MEMORANDUM

SUBJECT: Facility planning review—Bradley Boulevard Bikeway

RE: Bradley Blvd Improvements Project Phase I Facility Planning Study
From Glenbrook Road to Wilson Lane

DISCUSSION: Bradley Boulevard Improvements Project
From Glenbrook Road to Wilson Lane
Phase I Facility Planning Study
Project Prospectus Recommendations

Figure ES-2. Alternate 4A – 8' Shared Use Path North Side and Sidewalk South Side with Bikeable Shoulders Typical Section Looking East

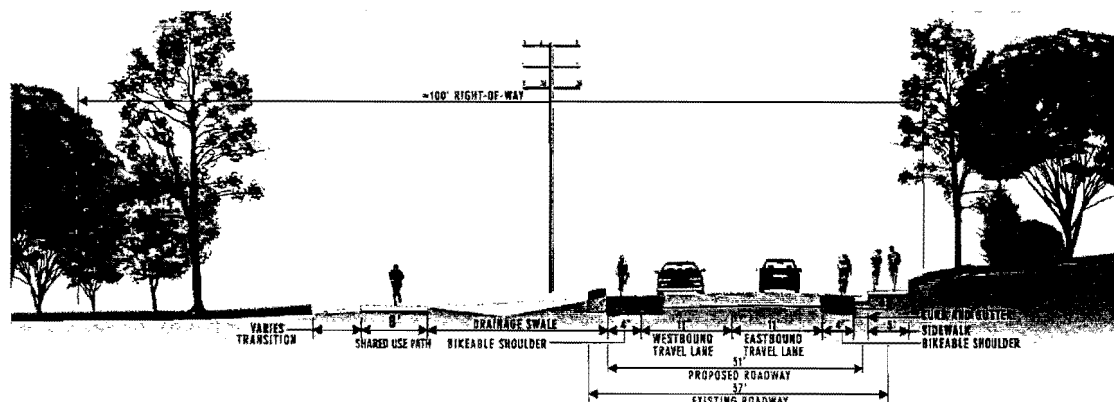
1. *Consider widening the 4'-wide bike-able shoulders to standard 5'-wide bike lanes, with appropriate marking.* Council staff disagrees. In just the past couple of weeks, the State Highway Administration has promulgated new standards that allow for bike lanes to be designated if they are 4' in width and if the roadway has a posted speed limit equal to or less than 35 mph (©32-33). Bradley Boulevard has a posted limit of 30 mph. The additional 2' would be better served on the shared use path (see the next recommendation).

2. *Consider setting the width of the shared use path at 10', reducing to 8' only at pinch points.* Council staff concurs. Shared use paths in the County currently range from 8-12' in width. The American Association of State Highway and Transportation Officials (AASHTO) and the Countywide Bikeways Plan each recommend a pavement width of at least 10'. The Countywide Bikeway Plan also notes that "Widths less than 10 feet may be acceptable where right-of-way is limited or for locations with severe site constraints" (©34). This means that the path's width could be reduced to 8' to help avoid a tree or utility pole. Although building a 10'-wide path would increase impervious surface slightly, it is enough of a difference to the riding experience and safety for it to be warranted.

5. *Provide a minimum 6'-wide buffer between the sidewalk and the new curb on the south side.* Council staff disagrees. Normally some type of buffer is desirable. In this case, however, there would already be a 5' gap between the sidewalk and the eastbound motor vehicle lane. Providing a 6'-wide buffer would require pushing the entire cross-section to the north by 6', with larger impacts on the foliage buffer.

8. *Use medians where possible for stormwater management.* Council staff disagrees. Even if the median were no wider than the drainage swale shown in DOT's Alternative 4A, the addition of inside curbs and shy area between the travel lanes and this median would push the cross-section a few feet further north.

Summary. Council staff recommends carrying Alternative 4A into the second phase of facility planning, with the following additional guidance:

- **Consider setting the width of the shared use path at 10', reducing to 8' only at pinch points.**
- **Prohibit parking on Bradley Boulevard in this segment to facilitate safe on-road biking.**
- **Consider adding a left-turn lane in each direction on the Wilson Lane approaches to Bradley Boulevard.**
- **Minimize the number of trees taken, carefully locate stormwater management facilities, and consider using the Filterra bioretention system.**

Figure 1: Cross Section for Recommended Alternative (4A)

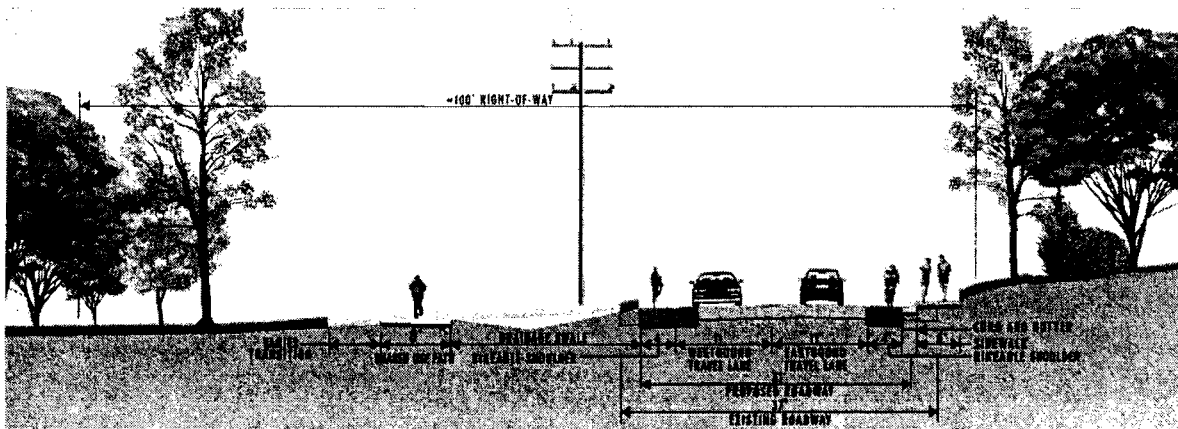
Landscaped Buffer: To the extent possible, a minimum 6 ft buffer should be provided between the sidewalk and the curb on the south side of Bradley Boulevard by shifting the roadway to the north where right-of-way is available. This will accommodate street trees and improve pedestrian comfort. A six-foot-wide buffer is also the minimum needed to avoid adjusting the sidewalk vertically or horizontally at every ADA ramp and driveway, which would make travel for disabled persons more difficult.

Tree Impacts: The number of trees required to be removed or adversely affected by this project should be minimized, in part by carefully locating and selecting the type of proposed stormwater management facilities. There is some flexibility in the location of proposed stormwater management facilities that could facilitate minimizing the number of trees that would need to be removed. In addition, MCDOT should consider the use of a Filterra bioretention system in place of some of the proposed bioswales. Filterra is a Maryland Department of the Environment-approved device that removes the pollutants in stormwater. This device is a sort of special concrete catch basin that achieves the same goals as the bioswales in a much smaller space and its use could result in the loss of fewer trees along Bradley Boulevard.

Stormwater Management: Use medians where possible for additional stormwater management.
